**WHITEMARSH TOWNSHIP SHADE TREE COMMISSION
MEETING OF MARCH 3, 2020 AT 7:00 PM**

Memorandum – Erdenheim Farms Tree Protection Fencing

Memorandum – 4106 Fountain Green Road

Memorandum – 901 Washington Street

LOCATION SKETCH OF TREE PROTECTION ZONE (TZ)
 FOR A 41.4" DBH LONDON PLANE NEXT TO A PROPOSED
 TRACTOR SHED

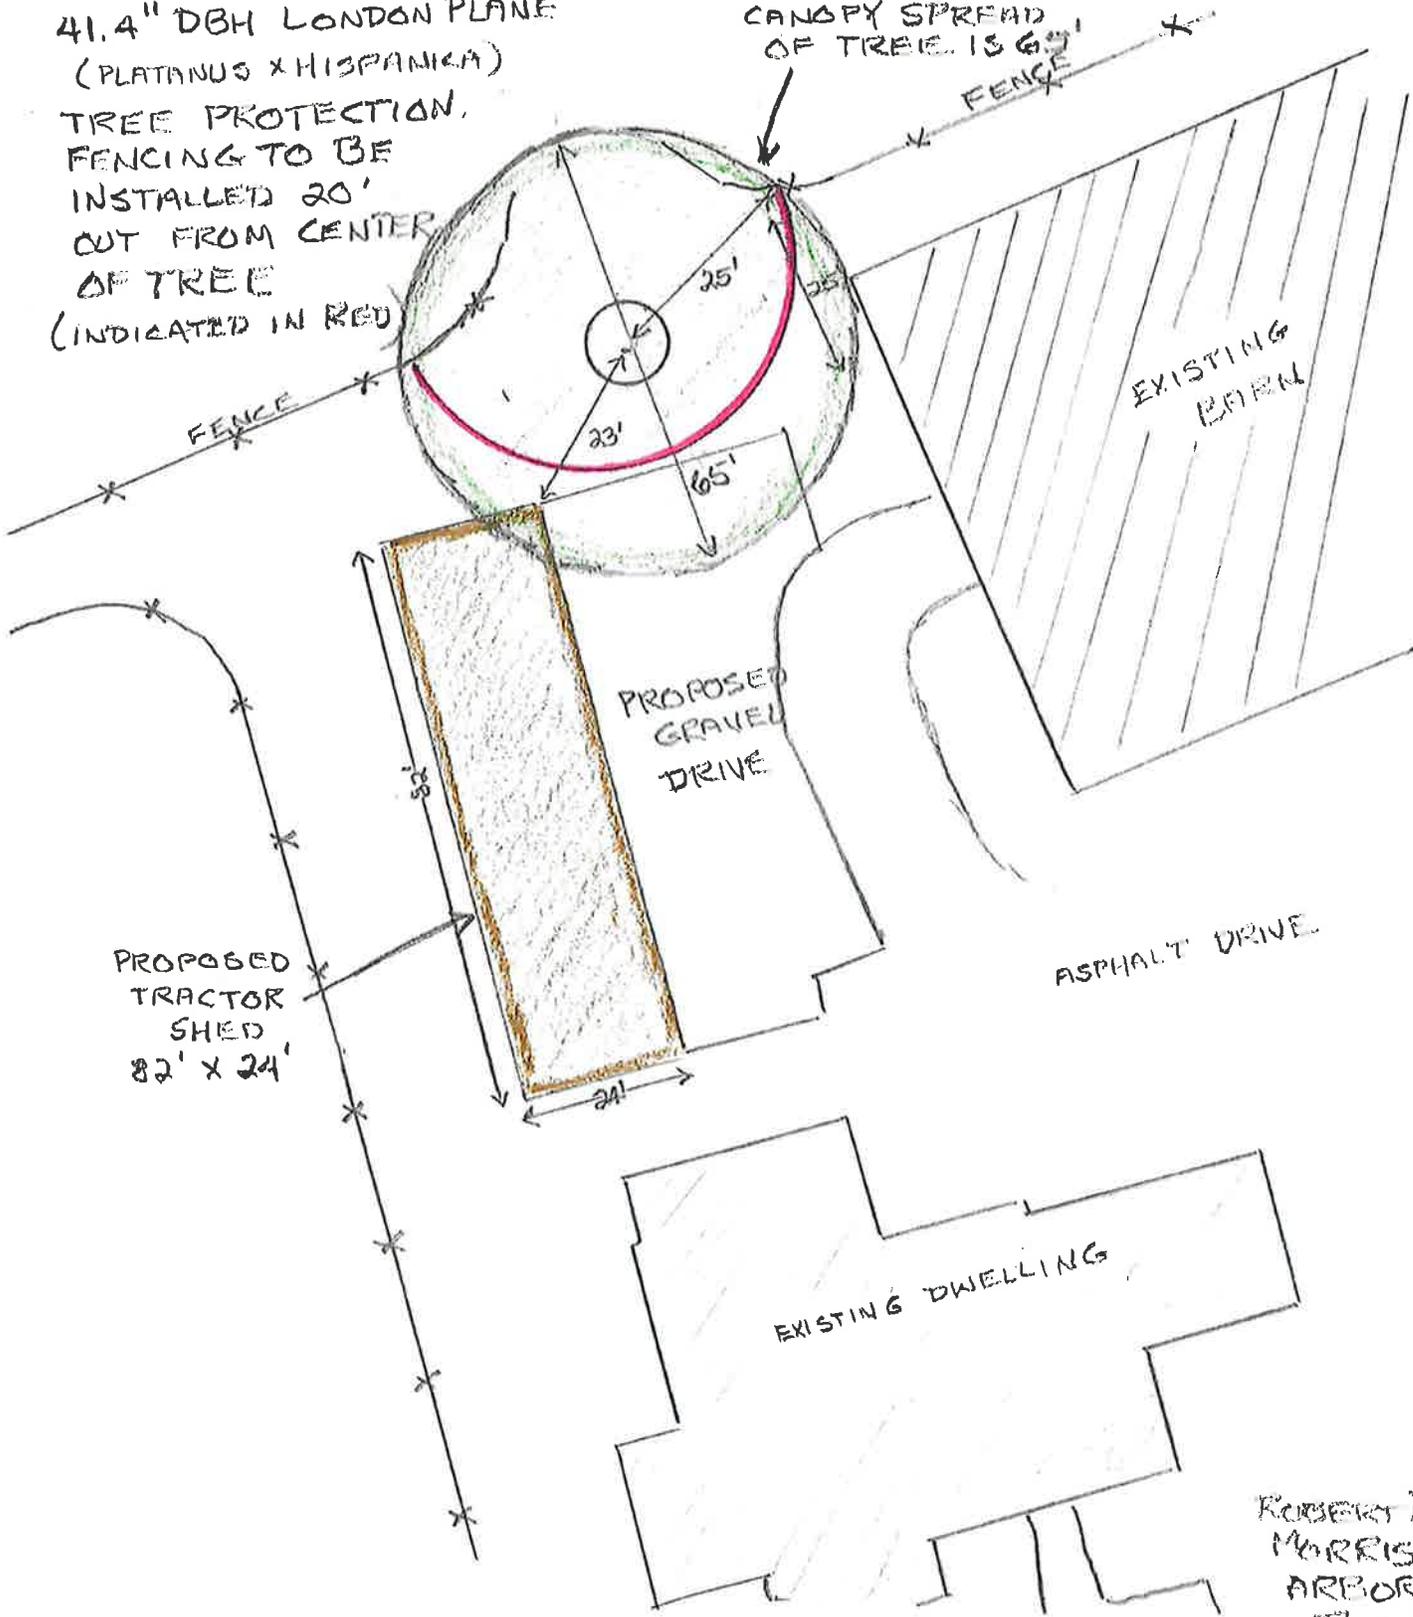
As per our recommendations for the applicant to provide tree protection for the subject barn project located at the Erdenheim Farms, Bob Wells From Morris Arboretum has provided a sketch detail that has sufficed our request. The subject tree London plane (*Platanus x hispanica*) is very healthy and does warrant preservation fencing to avoid contractor error.

The sketch below shows the fencing detail. This fencing is within the dripline, but I don't believe any conflicts will occur. I don't believe these needs to come back in front of us in March. The obligation has been met.

41.4" DBH LONDON PLANE
 (PLATANUS X HISPANICA)
 TREE PROTECTION
 FENCING TO BE
 INSTALLED 20'
 OUT FROM CENTER
 OF TREE
 (INDICATED IN RED)
